Model: High Capacity Stacker SK5020 (D515)	Date: 14-Jul-11	No.:RD515001a
--	-----------------	---------------

Subject: Firmware Release Note: High CapacityStacker SK5020		Prepared by: N.lida	
From: PP Service Planning Department 1G			
Classification:	<input type="checkbox"/> Troubleshooting	<input type="checkbox"/> Part information	<input type="checkbox"/> Action required
	<input type="checkbox"/> Mechanical	<input type="checkbox"/> Electrical	<input type="checkbox"/> Service manual revision
	<input type="checkbox"/> Paper path	<input type="checkbox"/> Transmit/receive	<input type="checkbox"/> Retrofit information
	<input type="checkbox"/> Product Safety	<input checked="" type="checkbox"/> Other (Firmware)	<input checked="" type="checkbox"/> Tier 2

Model: High Capacity Stacker SK5020 (D515)		Date: 13-Feb-12	No.: RD515002
Subject: Troubleshooting timing belt slippage		Prepared by: S. Sasaki	
From: 1st PP Tech Service Sec., PP tech service Dept.			
Classification:	<input checked="" type="checkbox"/> Troubleshooting	<input type="checkbox"/> Part information	<input type="checkbox"/> Action required
	<input type="checkbox"/> Mechanical	<input type="checkbox"/> Electrical	<input type="

Figure I

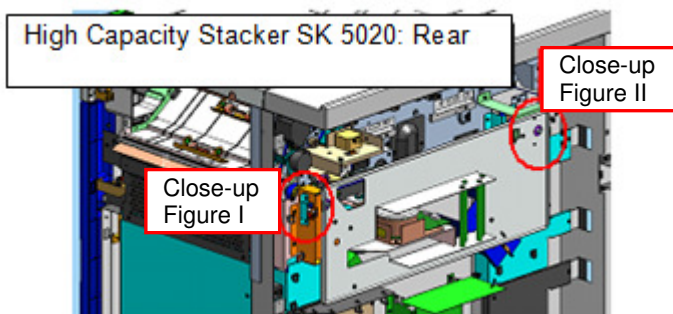
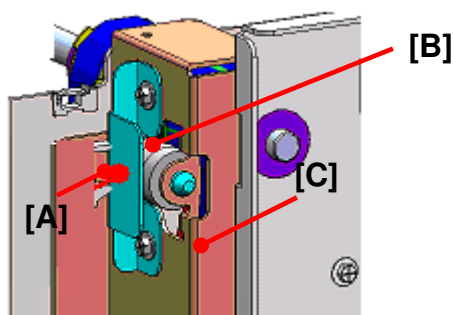
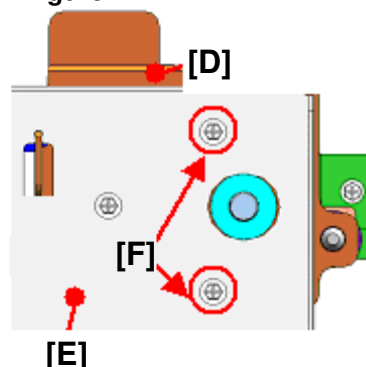
Step 1

Attach the bracket [A]. (D4474123: Bracket: Auxiliary: Timing Pulley: Ass'y)

Install the bearing [B]. (AE030030: Ball Bearing 8x19x6)

Replace the bracket [C]. (D4474121: Bracket: Protect: Drive Sub-unit)

Step 2

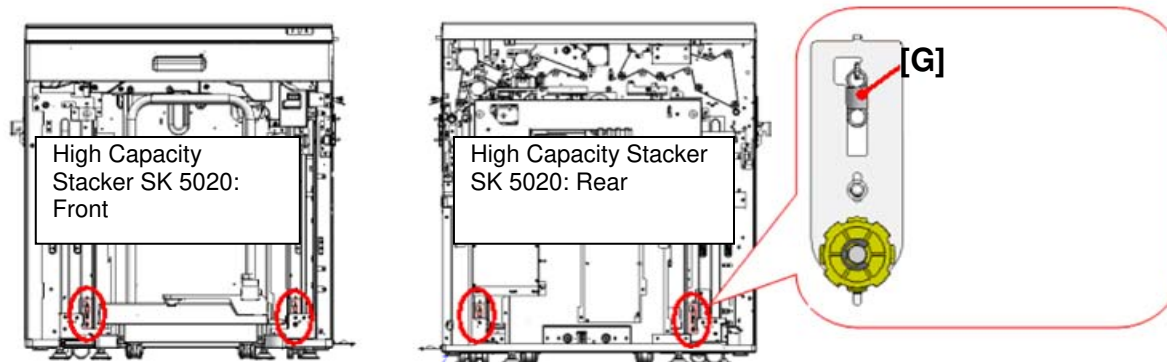
Replace the bracket [D]. (D4474425: Bracket: Protect: Shaft: Left Inner Rear)

Replace the supporting plate [E]. (D4474534: Supporting Plate: Timing Belt)

Fasten the two tapping screws [F]. (04514006N: Tapping Screw 4x6)

17.Drive Section 2 (D447)

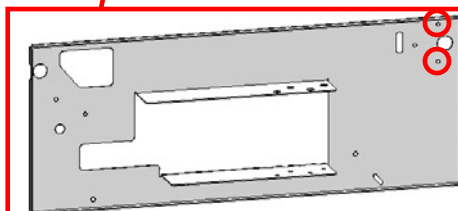
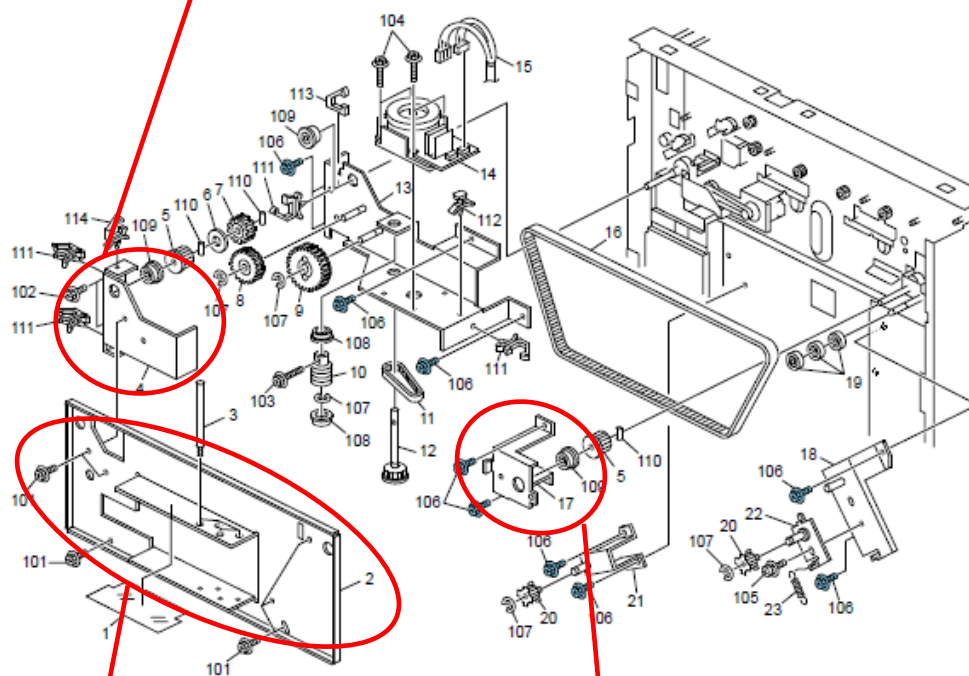
The shape of the part was changed.

The two screw holes were added.

The two screw holes were added.
